SERVICE KIT: #38

SUBJECT: Installation – Retainer - Pin Shock Strut

MODEL: 3000, 3450 Amphibian Floats.

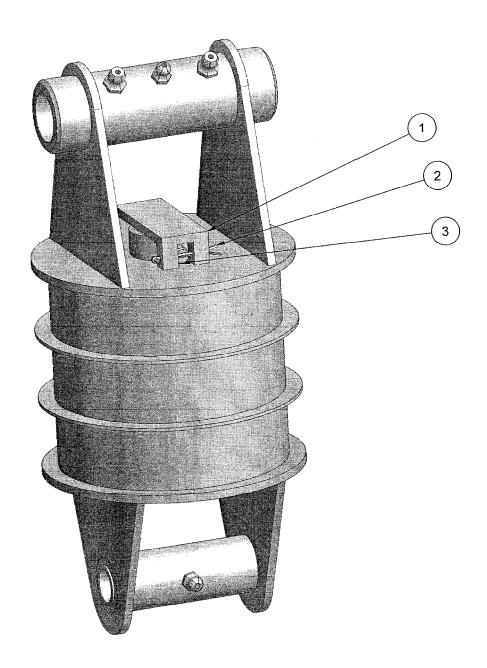
- 4. Install item (1) p/n 21A04193-007 retainer in top of shock strut tube, line up holes. Install retainer so cotter pin holes face aft.
- 5. Install item (3) p/n 21A04503-004 retaining pin, thru shock strut tube & item (1) retainer. Install item (2) MS24665-155 cotter pin in retainer legs, this will prevent item (3) retaining pin from coming out of shock strut tube.
- 6. Reinstall access cover, and remove weight.
